RFT# 4239 - Addendum #2 Heat Pumps and Electrical Service Bicentennial School

To: All Bidders
Date: May 30, 2024
From: Nancy Rideout, Purchasing Manager
Office: (902) 464-2000 ext. 2222
Email: nrideout@hrce.ca

PROJECT
BICENTENNIAL SCHOOL - HEAT PUMPS AND ELECTRICAL SERVICE

S-101.1

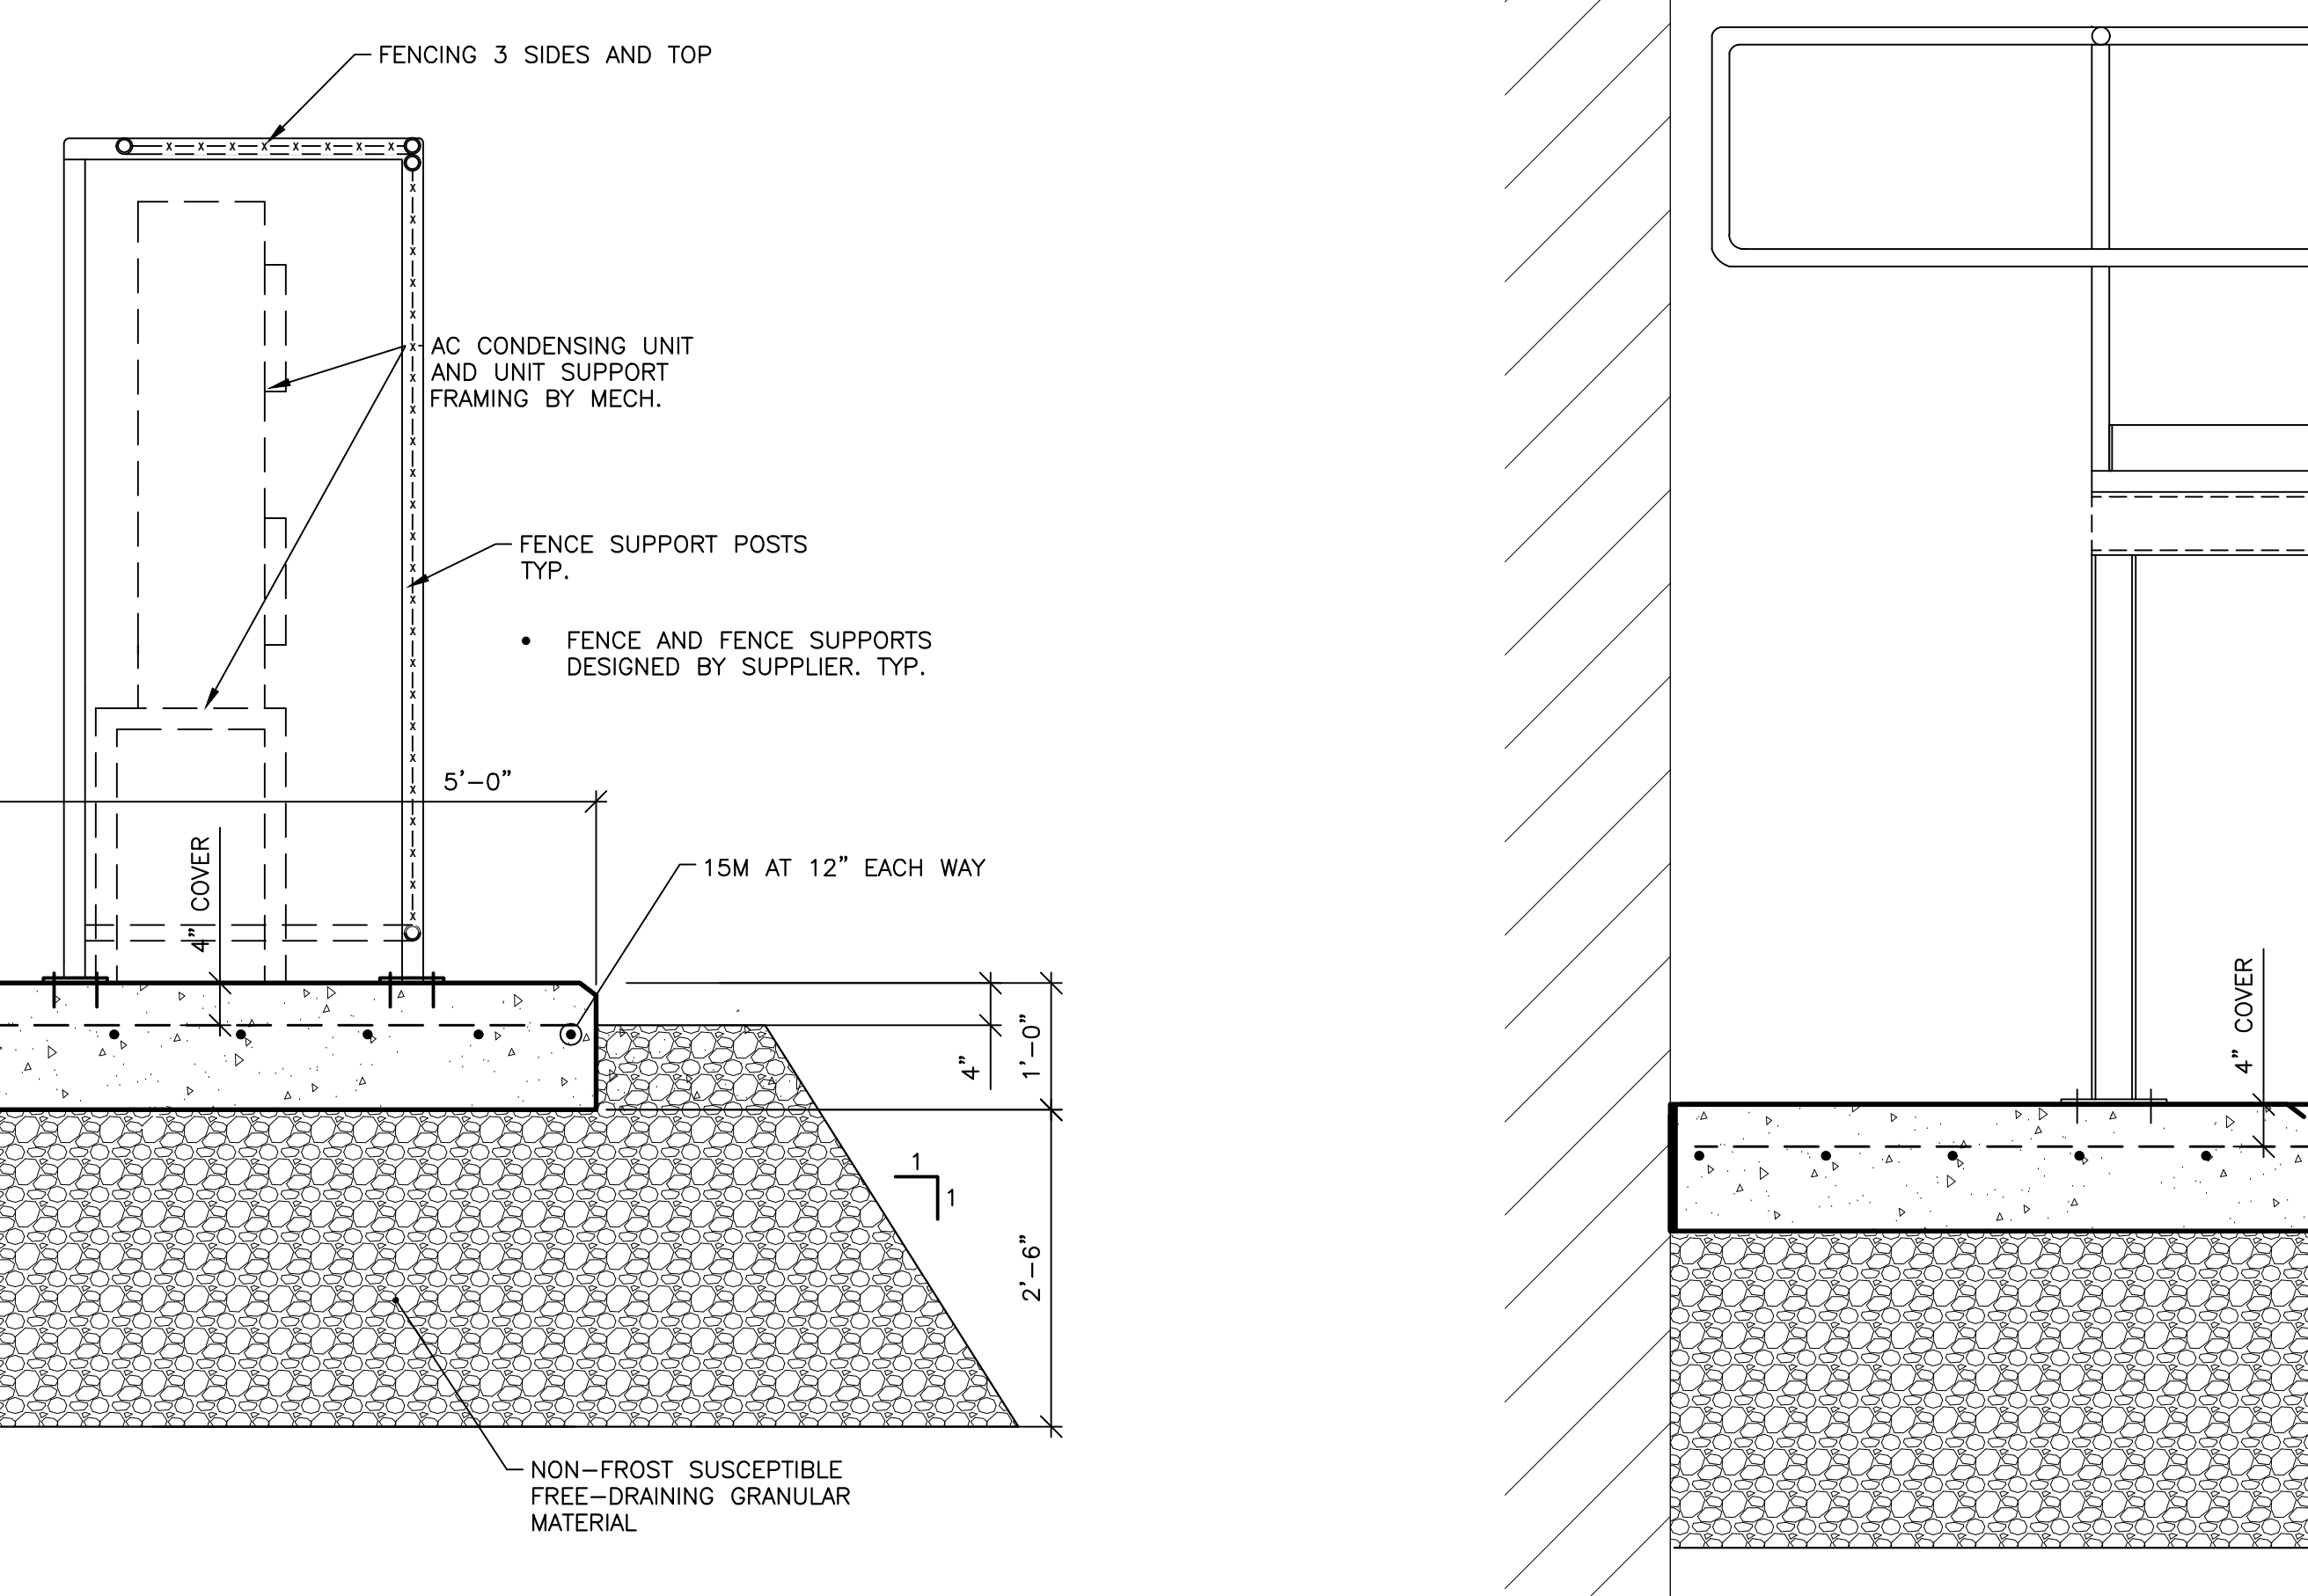
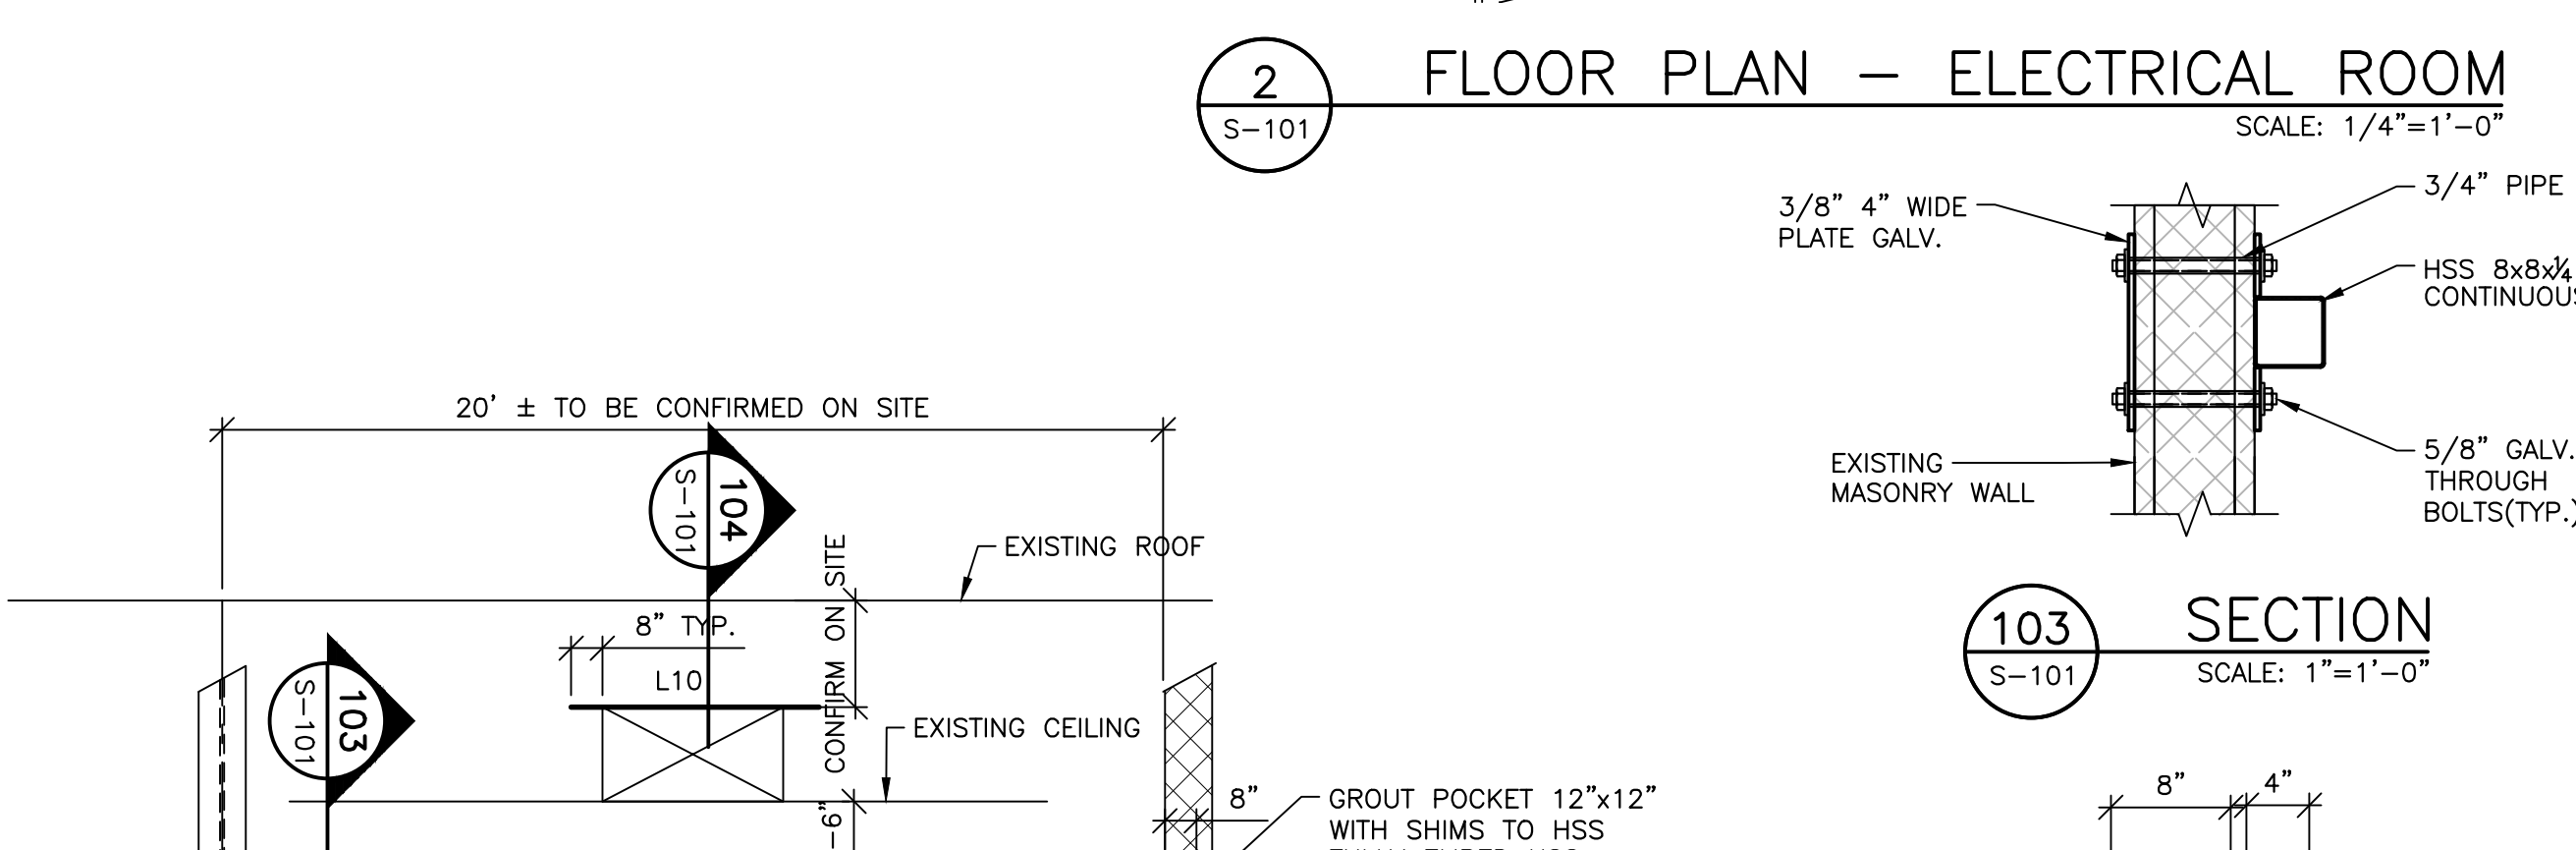
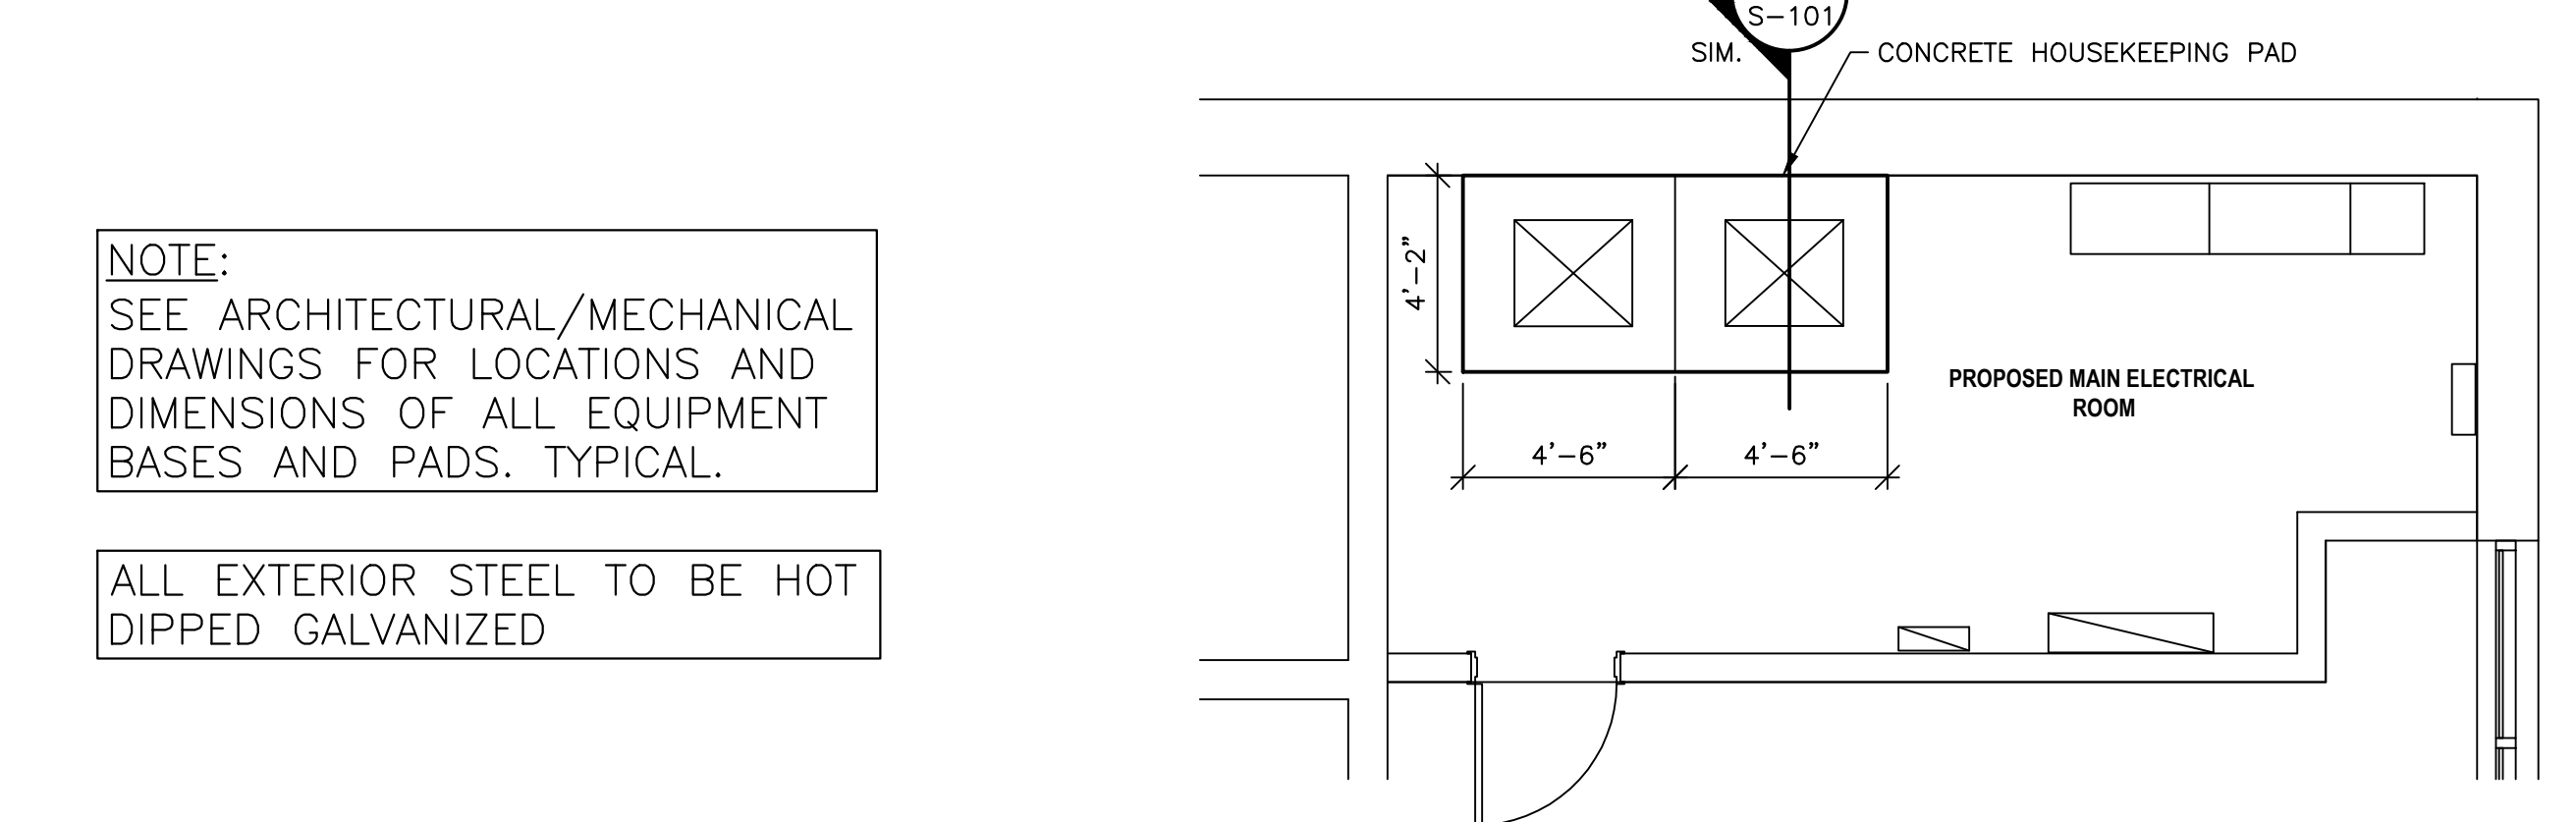
(Part 3) On drawing MV-104, there is a note regarding the structural stand for AC-1 to see structural drawings for information. Assuming the stand is part of this tender package, please provide structural drawings.

(Part 3) Structural drawings are included with this addendum. Refer to "Additional Information" at the end of Addendum #1.

- 1) Structural drawing S101.1 STRUCTURAL DETAILS – Enclosed – 24 MAY 2024
